SERVICE BULLETIN

M1603

M1603: RECALL 0181 SOFTAIL SHOCK ADJUSTER

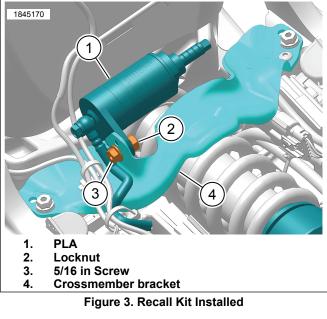
- 6. See Figure 3. Install PLA (1) to crossmember (4).
- Install 5/16-inch screw (3) and locknut (2). Tighten. Torque: 32.8–36.3 N·m (24–27 ft-lbs)
